TO:	CHAIR AND MEMBERS BUILT AND NATURAL ENVIRONMENT COMMITTEE OCTOBER 31, 2011
FROM:	JOHN LUCAS, P. Eng. ACTING DIRECTOR, ROADS AND TRANSPORTATION
	580 FANSHAWE PARK ROAD EAST

The purpose of this report is to provide the Built and Natural Environment Committee with the results of the traffic patterns review and access assessment for the proposed development located on 580 Fanshawe Park Road East and the adjacent Fanshawe Park Rd E & Adelaide St N intersection.

Figure 1

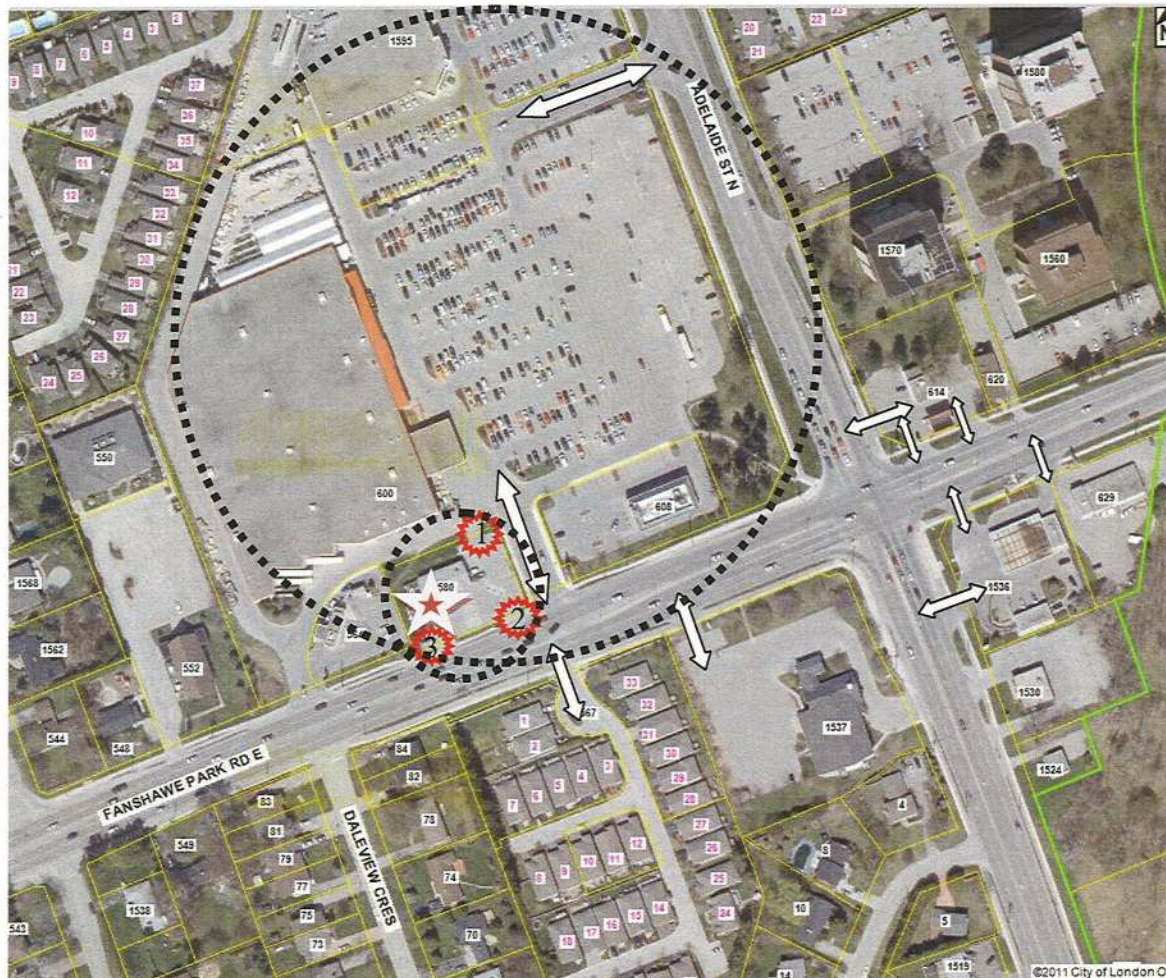
The subject site, 580 Fanshawe Rd East, is located near the northwest corner of the signalized Fanshawe Park Rd E & Adelaide St N intersection. Three access locations are proposed for this site as requested by the developer. Full internal driveway access (#1), full access to Fanshawe Park Rd (#2), and a drive through exit to Fanshawe Park Rd (#3) as shown on Fig. 1 below.

Although the proposed development at 580 Fanshawe is not expected to have a direct or significant impact on the adjacent main intersection, it has significant access conflicts with Fanshawe Park Rd and the other surrounding existing accesses. To put this into perspective, the Developer is seeking 3 access locations (shown below within the small circle) compared to 2 major existing access locations and a third minor access to the north on Adelaide St that serve a much bigger existing development (Home Depot, Sobeys, Pharma Plus, & TD Bank as shown within the big circle). Transportation Division does not support the proposed access #2 (see figure 1 below).

Transportation does not support access #2 and it should be eliminated when a site plan is submitted. The drive through exit (access #3) will be reviewed when a site plan is submitted to assure conformity with the zoning by-law with respect to drive throughs. As such, access #1 (a common internal driveway with development to the north) will be the main full access to the subject site for the following reasons:

Figure 2

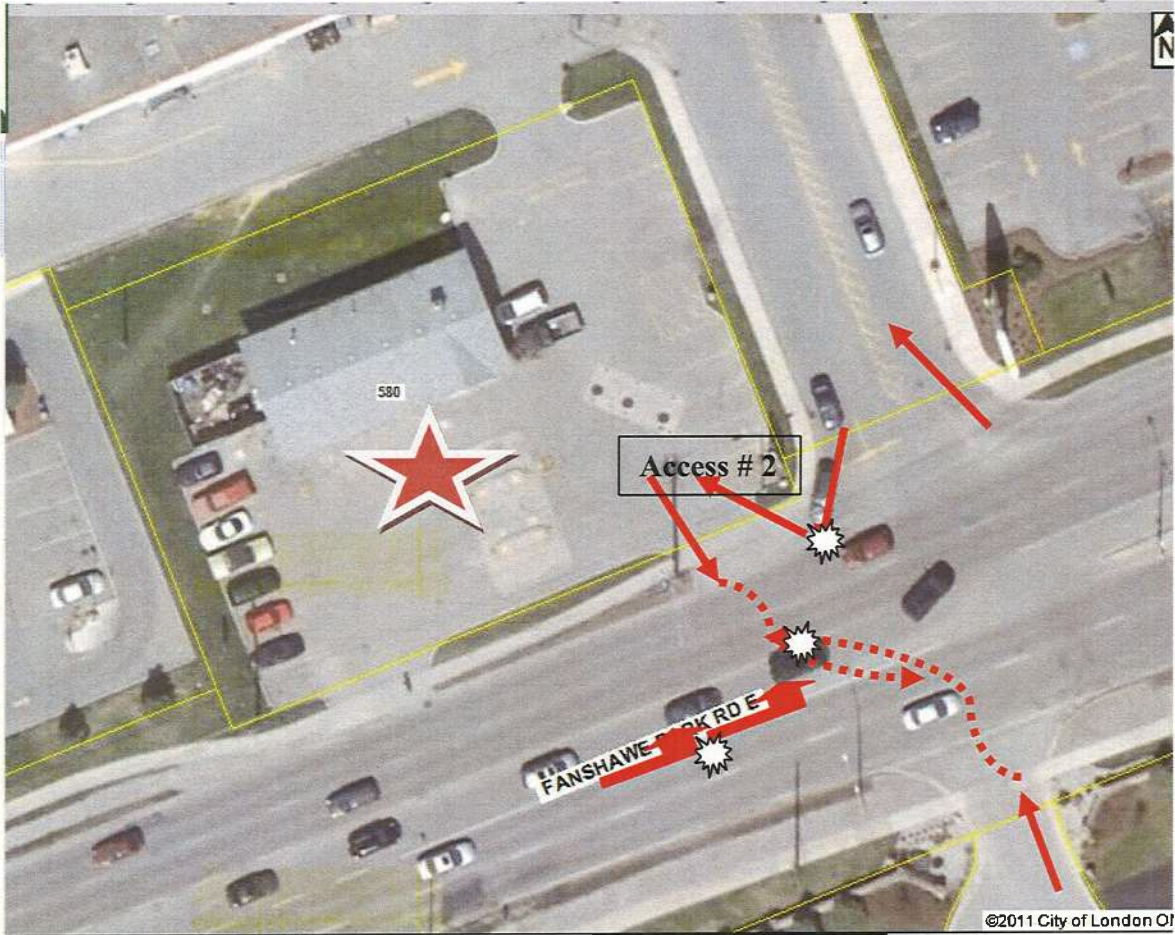
The following summarizes the main conflicts and impact of the requested full access on Fanshawe Rd (See figure 2 below):

- Access #2 overlaps the existing access to Home Depot and other commercial buildings.
- Confusion for drivers exiting the Home Depot site to make a decision whether traffic approaching from the east and giving a right turn signal is turning right on the Home Depot access or on the proposed access to the subject development. This will result on potential collisions.

- Conflict of left out turning movements between traffic exiting the subject site and residential development south of Fanshawe Park Rd, which may result in collisions.

- Conflict of left in turning movements to the subject site and the Home Depot site. A driver turning left to the Home Depot site may not expect the driver on the front is turning left to the subject site due to overlap of both entrances causing rear end collisions.

- The location of Access #2 does not conform to the City's Access Management Guidelines with respect to the typical spacing of 30 to 60 meters of driveways along an arterial.
